Subject: UniStar Nuclear Energy, NRC Docket No. 52-016  
Response to Request for Additional Information for the  
Calvert Cliffs Nuclear Power Plant, Unit 3,  
RAI 268, Stability of Subsurface Materials and Foundations

**Response to NRC Request for Additional Information RAI 268, Question 02.05.04-24 and  
Question 02.05.04-25, Stability of Subsurface Materials and Foundations,**

**RAI 268**

**Figure 1**  
**Center Points for the Nuclear Island Buildings**

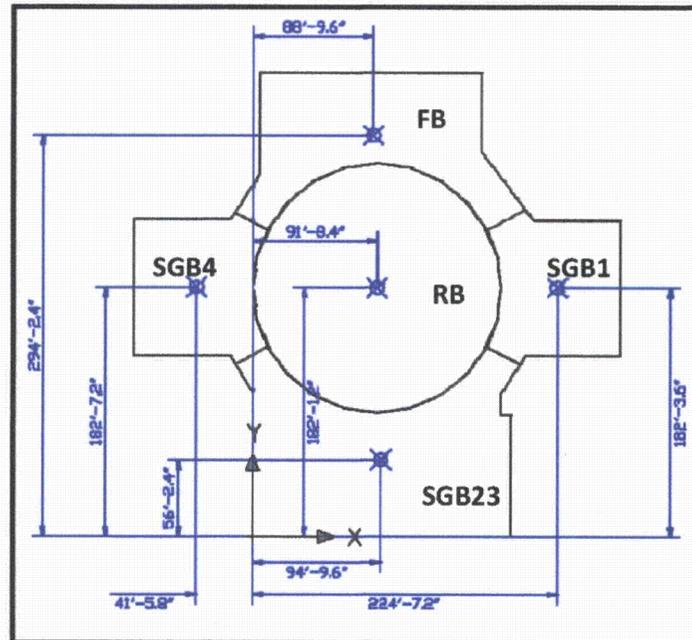
1. Describe how the foundation dimensions were determined and used as input in the Slope/W and Plaxis 2D analyses. Also describe if non-uniform loading condition(s) on the foundation were considered.
2. Figures 6 and 7 in the RAI response present the ultimate bearing capacity analysis results, and you stated that the ultimate bearing capacity was reached when "a significant decrease in stiffness was observed" during the Plaxis 2D model analysis. Describe and justify the criterion that was used to determine the stiffness that corresponds to the ultimate bearing capacity.

1. The bearing capacity analysis outlined in the response to RAI Question 02.05.04-15<sup>2</sup> was based on an equivalent rectangular shape representing the Nuclear Island (NI). The equivalent shape has the same moment of inertia as the original footshape. The equivalent foundation width and length were  $B = 270$  ft and  $L = 300$  ft, respectively. The non-uniformity of loads on the NI was evaluated by calculating the moment at the center of the footprint. The moment due to the loads of each building was calculated using the equivalent point load representing the area load. The moment arms were in accordance with Figure 1. The equivalent loads, moment arms, and moments for each building at the NI are given in Table 1.

Effective equivalent width and length due to the eccentricity ( $e_B$  and  $e_L$  in both directions) created by the moment at the center of the NI are  $B' = B - 2e_B = 268.9$  ft and  $L' = L - 2e_L = 298.1$  ft. Effective equivalent width and length are very close to their equivalent counterparts, which formed the basis for the assumptions of using average load over the NI, and using equivalent width in Plaxis 2D and Slope/W models.
